CENTERVILLE CITY PLANNING COMMISSION AGENDA

- 7:05 1. **PUBLIC HEARING | 1872 NORTH MAIN SUBDIVISION | 1872 NORTH MAIN STREET**
 Consideration of a conceptual subdivision with flag lots for the 1872 North Main Subdivision; which consists of 4 lots, located in the R-L Zone. Paul Cutler, Applicant

- 7:45 3. **WOODS PARK SUBDIVISION | 690 WEST 2400 NORTH (LUND LANE)**
 Consideration of a final subdivision plan & plat for the Woods Park Subdivision, which consists of 29 building lots, located at 690 West 2400 North, in the R-L(PD) Zone. Alan Prince, Prince Development, Applicant

- 8:05 4. **PUBLIC HEARING | CHASE LANE CULINARY WATER PUMP HOUSE | 70 E CHASE LN**
 Consideration of a final site plan and conditional use permit for a public utility substation for the Chase Lane Culinary Water Pump House, located at 70 East Chase Lane, for the construction of a new well site in the R-L Zone. Centerville City, Applicant

45' Wide x 45' Deep
(LOTS 1,2,8,20,24,28)

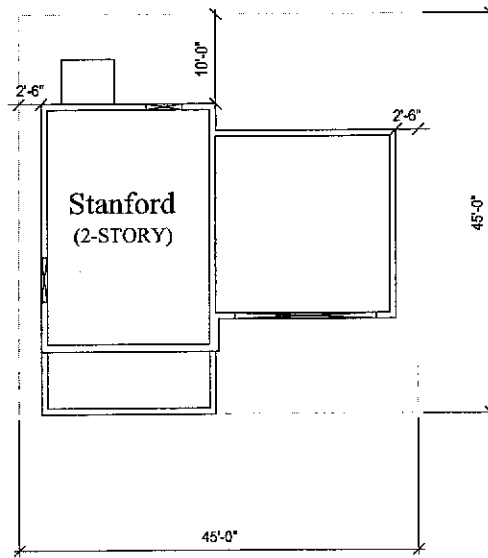
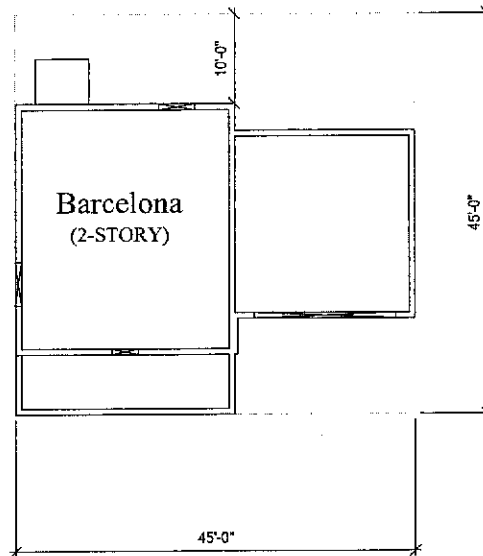
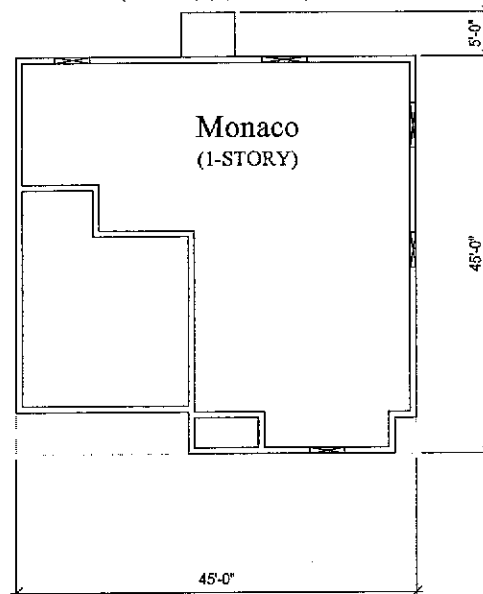
- j. Deck setbacks shall meet City Standards. The applicant may address use of uncovered decks for modification review.

Cory, as you can see, the amount of protrudance by decking into the backyard of any home plan is 6 feet, and only for a brief width. We would like to propose that (a)no deck area be permitted to be covered which protrudes in any manner into the rear setback area. (Covered decks are fine, but only if they fit into the regular building pad space). No deck be permitted to invade any rear setback area further than 6 feet, and no deck to be wider than 15 feet. Thanks. Alan

➤ **Staff Response:** Compliance = To be determined. The applicant is requesting that a maximum allowance of 6'x15' uncovered decks be approved with the final plans.

SITE PLAN

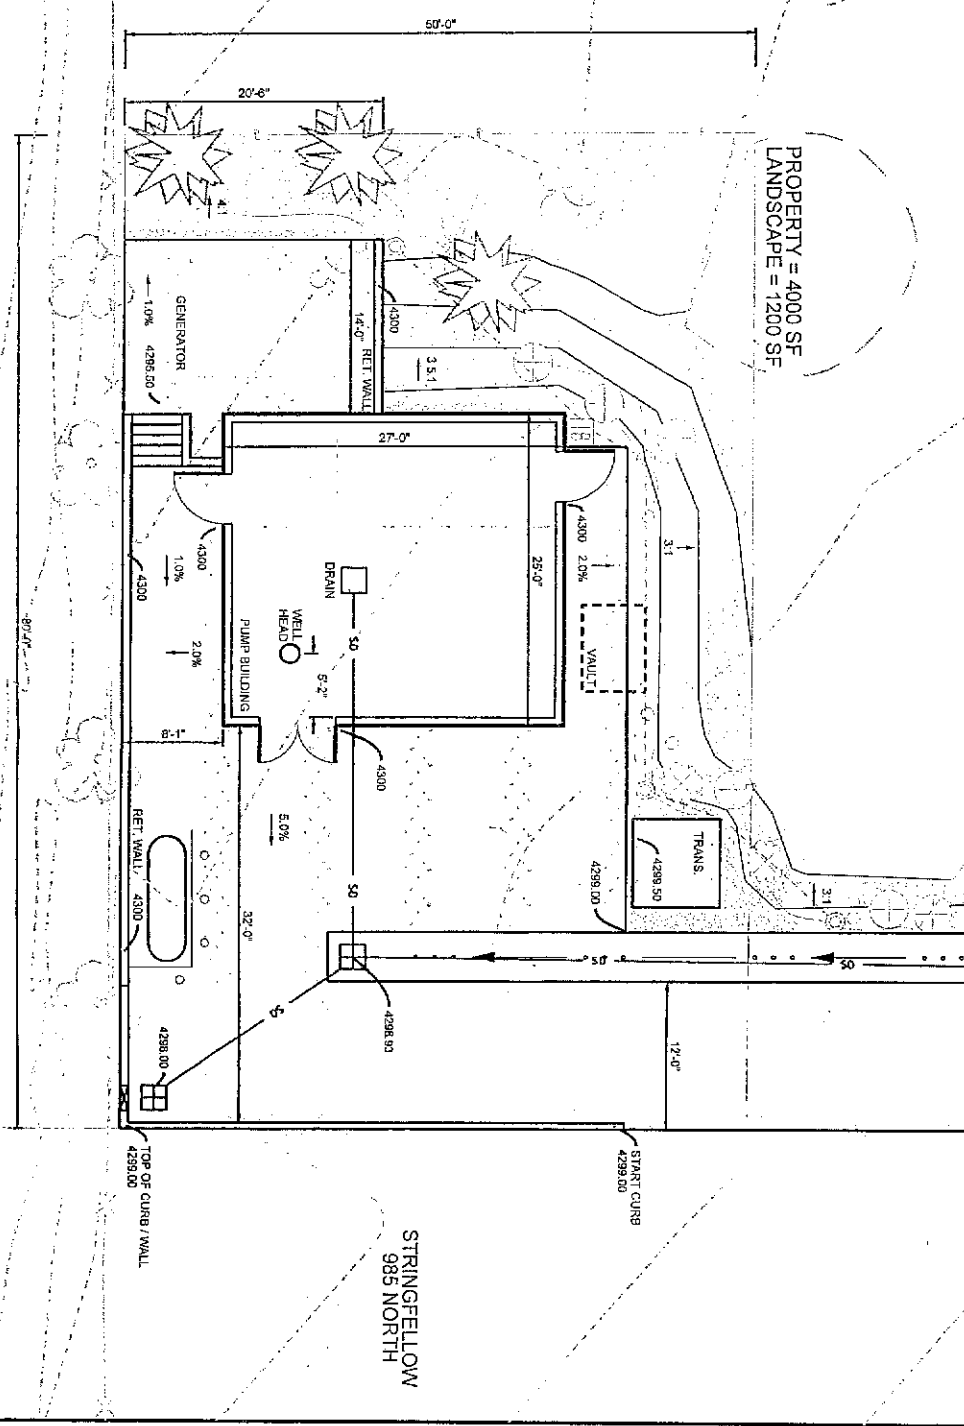
4. The final site plan shall include landscaping detail in regard to how the site will be maintained. This plan shall include type of groundcover, vegetation type, irrigation detail and a drainage plan.

5. Unnecessary hard surfacing shall be reduced to a minimum in order to reduce run-off and increase the landscaped area.
 - Staff Response: Originally the site called for a larger drive entrance, however, the hard surfacing has been reduced for the drive-isle to 12 feet with a 4 foot wide waterway. In addition, the drainage has been evaluated to ensure that almost all run-off will occur on site and through the new drainage system that will be installed. The City Engineer stated the site for the well is 4,000 square feet and the landscaping will cover 1,200 square feet or 30%.

- Staff Response: A plan has been provided that indicates all groundcover, vegetation and irrigation. The desire is to use a 4" cobble for groundcover with low maintenance shrubs and trees that will be watered by drip irrigation. The shrubs and trees will be planted in a way that will block that transformer, generator, and break up the building. The Public Works Department have met with the applicant on several occasions to discuss the landscaping and to ensure that it will blend in with the Griffiths property. They also desire that it be easy to take care of and not place a burden on the City or Mr. Griffiths. Landscaping plans are found at the back of the report.

- Condition #4 - a plan showing type of groundcover, vegetation, irrigation detail and drainage plan is provided herein. On the gradual side slopes (3:1 to 4:1) it is proposed to use a 4" minus cobble material over a weed control fabric for ground cover. A drip irrigation system will be installed to water each bush and tree. The water supply will come from the building. The intent of the bushes and trees is to block the transformer and generator from view and to break up the building.

- Condition #5 - Hard surfacing has been reduced from the previous plan along the drive entrance from 20' wide to 16' wide. A 4' wide concrete waterway has now been scheduled along the west side of the 12' wide concrete drive entrance such that the drainage from the driveway will flow to the south and be completely captured in the inlet on site. Thus virtually all run-off from the new pump building site will be contained on site and discharged through the new drainage system being installed. The site is 4,000 SF and it is proposed that there be approximately 1,200 SF of landscaping (30% of site).
